CCL 23/02/21 – WOOD STREET, NEWCASTLE WEST – ONE WAY TRAFFIC FLOW SOUTHBOUND DIRECTION, ANGLE PARKING AND RAISED PEDESTRIAN CROSSING BETWEEN HUNTER AND PARRY STREETS

PAGE 3	ITEM-6	Attachment A:	Wood Street, Newcastle West – Community Consultation Leaflet for Project Concept Plan
PAGE 7	ITEM-6	Attachment B:	Wood Street, Newcastle West - Community Consultation Results

**SUMMARY OF THE CONSULTATION
WOOD STREET, NEWCASTLE WEST - PROPOSED ONE WAY TRAFFIC FLOW AND ANGLE PARKING**

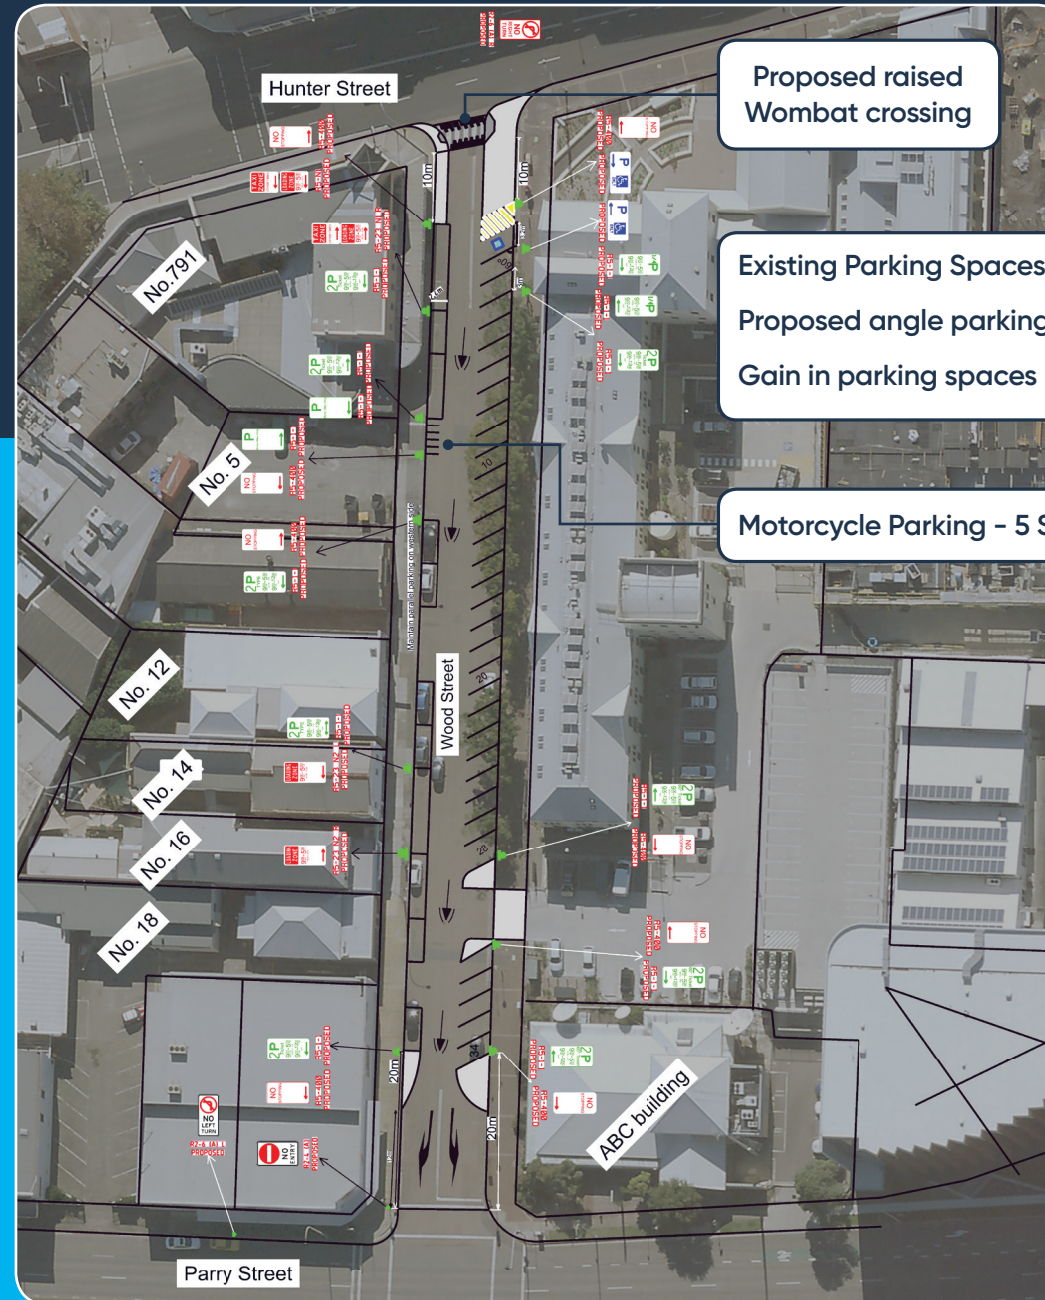
LOCATION	RESPONSE	WHAT CHANGES WOULD YOU LIKE CONSIDERED?	CN RESPONSE
Waratah	Yes, with changes	<p>1. Additional 'no left turn' sign to be placed at the traffic control lights at the intersection of Parry Street and Wood Street.</p> <p>2. Move the loading zone from outside #14 Wood Street further south to the end of the 2P parking zone to allow for easier parking for larger vehicles utilising the loading zone.</p>	No left turn sign to be added in detailed design stage. Loading zone preferred near to the hotels and CN entrances.
Swansea	Yes, with changes	Perhaps one more disabled parking spot and one or two more 15 min parking spots.	Will be considered in the detailed design stage.
The Junction	Yes, with changes	Reduce speed limit on Wood Street to 30kph. Angle parking is dangerous for cyclists in the roadway, as well as other traffic flowing past. Also, the Wombat crossing at the northern end of Wood Street should accommodate the separated cycleway to be delivered as part of the West End Streetscape Plan Stage 2.	Cars are currently driving at an average speed of 34.8 km/h in Wood Street. The Wombat crossing will be designed to complement the West End Streetscape Plan for cycleway Stage 2.

Bronte	No	Less parking better footpath and bicycle facilities, will lead to less vehicle traffic which encourages people to walk and ride a bicycle.	Noted comments.
Mayfield	Yes	Correct signage as the signage currently in place may be incorrect - length to be parked from traffic lights.	Will be done in detailed design.
Newcastle	No	None	
	No	<p>To currently get to Wood Street from Hannell Street we are no longer allowed to turn right at the Hunter Street lights (and left onto Wood Street), but have to turn right through the major Parry Street intersection - no longer allowed to turn right onto Wood Street but onto Denison Street and perform a safe U-turn to get back onto Parry Street and left onto Wood Street. Can you see where I'm going?</p> <p>The argument from traffic control would be its not great hassle to drive to end of Denison Street, left onto Hunter Street and left again onto Wood Street. Distance-wise no it's not a hassle. The hassle is having to cross two busy lanes (which are double lined for good reason) of Hunter Street twice, potentially hold up traffic in the right lane heading into the CBD. Please consider the negative and very frustrating 'roundabout effect' that is starting to appear in the CBD (notably Worth Place, when there is heavy traffic on Honeysuckle Drive you cannot go down Hunter Street as an alternative route).</p>	<p>The route from Hannell Street (southbound direction) will not be impacted as there is already an existing no right turn from Hannell Street to Hunter Street and no right turn from Parry Street to Wood Street. The proposed one-way traffic flow in Wood Street will not impact the current alternative route from Hannell Street.</p> <p>Noted comments of concerns.</p>

LOCATION	RESPONSE	WHAT CHANGES WOULD YOU LIKE CONSIDERED?	CN RESPONSE
Hamilton	Yes, with changes	More gardens and trees put in the street with the extra space. More bike hoops for cyclists. It would be nice to extend the outdoor dining section of the Cambo out or at least put bike hoops and trees in this section.	Detail streetscape design to incorporate that.
Belmont North	Yes, with changes	<p>Wood Street is the dedicated road for Assembly Points for multiple businesses including the CAC building recently which up to 3 months ago was across the road in the park but getting across the road deemed a challenging task so it was deemed that all of the Northern side of our building musters to the western side of Wood Street and all of our Council side of the building musters to the eastern side of Wood Street which at full capacity during an emergency is 600-700 people not including people evacuating Forsythes via the back entrance at No:5, Cambridge, ABC and more important the Motel along Wood St etc. I support the one way road but would suggest widening the verge and keep parallel parking or provide pockets of angled parking and a few large wait areas with trees for people to relax under (for lunch breaks) or wait under in the event of an emergency as this street could host up to 700 - 800 people in the event of an emergency / false alarm . Also with the increase of business from across the road will increase foot traffic in the near future would aid in some improved green spaces.</p> <p>Also I think there are a few disabled parks (hard to read) but the line spacing seems equal, but the capacity may be reduced as the disabled parks will need to be wider to allow access from the side of a vehicle or deeper for rear access from a deployed ramp along with kerb ramps for getting in and out and on / off the footpath.</p>	<p>Eastern and western footpath width does meet the capacity to accommodate more than 1,000 people.</p> <p>Disabled parks will be designed as per Australian Standard in the detailed design plan.</p>

New Lambton	Yes, with changes	By limiting travel to southbound only, all traffic using this street will be turning directly onto the pedestrian crossing without a left turn slip lane on Hunter Street. This means vehicle speeds approaching the pedestrian crossing will be at the prevailing speed of Hunter Street traffic (or slowing a lane down), with only peripheral view of the pedestrian crossing prior to making the turn into Wood Street. Why not direct traffic northbound only with left turn only onto Hunter Street? Northbound traffic approaching the pedestrian crossing from the quieter Wood Street has a direct line of site view on approach to the pedestrian crossing. In addition to this vehicle on Wood Street will be travelling at a slower speed, and able to give way to pedestrians at the crossing without interfering with the flow of traffic on Hunter Street.	<p>Detailed design in conjunction with West End streetscape design will accommodate a reserve space for car turning left from Hunter Street to address this issue.</p> <p>The safety issue to be addressed in this project is the car turning left from Wood Street to Hunter Street and not seeing pedestrians crossing at the traffic signal lights in Hunter Street.</p>

LOCATION	RESPONSE	WHAT CHANGES WOULD YOU LIKE CONSIDERED?	CN RESPONSE
Adamstown Heights	No	One-way traffic flow only at the Hunter Street end of Wood Street. i.e stopping cars from existing Wood Street onto Hunter street to address the pedestrian issue raised, but still allow two way traffic at the Parry Street end of Wood Street. Making Wood Street one way will mean many cars will have to go 'around the block', through the two large intersections on Stewart Avenue at Parry and Hunter Street to be able to enter Wood Street. This is likely to result in many cars taking the 'short cut' through the 12 Stewart Avenue driveway which goes through the Quest Apartments car park and onto Wood Street.	Impact of same to be monitored as the delay at the entrance of Stewart Avenue driveways will force motorist to Wood Street. The volume of traffic is low in Wood Street and the likely short cut through 12 Stewart Avenue driveway is minimal.

Unknown	Yes	It would be good to see some 4-hour zones within the city; this would be a good place to trial this. if one of the 2-hour zones were changed to 4 hours.	Parking demand after implementation to be reconsidered.
Newcastle	Yes, with changes	Dual direction travel on a bicycle by putting in a protected cycle path on each side. The lack of provision for cycling is key here. This is a key linking road from Newcastle Foreshore to Hamilton.	Detailed design in conjunction with West End streetscape design will address this issue.
Newcastle West	No	We believe it should remain 2 way on behalf of Quest Newcastle West we believe turning Wood Street into a one way street will significantly affect the access to our apartment Hotel, particularly as most of our visitors are from out of Newcastle, and therefore are not familiar with the blocks and which way to turn in order to access our apartments. This is particularly the case for those coming from Sydney from the Wallsend exit and those using Industrial Drive from the airport and northern areas. As a tourist destination this does not provide a good first impression of our city. We strongly believe that the street needs to remain 2 way.	Street directions signs to direct motorist, will be considered in detail design stage. Comments noted.

Tighes Hill	Yes	Makes perfect sense to me!	
The Hill	Yes, with changes	Keep the raised Wombat crossing at Hunter Street but make it a bend out intersection as per page 36 of West End Stage Two Streetscape Plan to allow vehicles to give way in the intersection. Allow for future works under the West End Stage Two Streetscape Plan by including a section of the cycleway at Hunter / Wood Streets intersection. Or don't include it but allow the space to do so in the future.	The bend out and the cycleway consideration will be considered in the detailed design stage.

LOCATION	RESPONSE	WHAT CHANGES WOULD YOU LIKE CONSIDERED?	CN RESPONSE
Newcastle West	No	<p>Leave Wood Street as a two way street as this will reduce the risk to pedestrians.</p> <p>We would like to bring to your attention that by implementing the proposed changes, you are actually increasing the risk to pedestrians as currently the main vehicular access to the Quest Newcastle West carpark is via Wood Street. Redirecting the traffic in a one- way south bound direction would cut off direct vehicular access to the hotel car park and would force hotel guests around the block via Stewart Avenue and Parry Street to access the carpark. This will result in a significant increase the vehicular traffic through the pedestrian crossing that you are trying to mitigate the risk from which would have otherwise turned left directly into Wood Street from Parry Street.</p> <p>We see the proposed changes as a much higher risk to pedestrian safety, given we have 78 accommodation rooms you are now forcing a significant amount of vehicular traffic, often first time guests who are not familiar with Newcastle on a massive detour around the block, who will be looking for signage and then forcing them onto the pedestrian link that you are trying to mitigate the risk from and potentially missing pedestrians because they are lost. We believe the proposed changes are self-defeating and will actually achieve a worse outcome for pedestrian safety.</p>	<p>Street signs to direct motorist, will be considered in detail design stage.</p> <p>Comments noted.</p>

Newcastle	Email received as a concern	<p>It is worth flagging that there are at least several waste containers presented kerbside for collection along this street (western side).</p> <p>The collection vehicles that service this area are one-man side loaders, which collect from the left hand side of the vehicle, which will be the opposite side to the road which the bins are presented for collection if the one-way direction is approved. This shall make collection of these bins not possible under the collection methodology as it currently stands (without modification to the process).</p>	<p>Modification process will be considered for waste collection.</p>
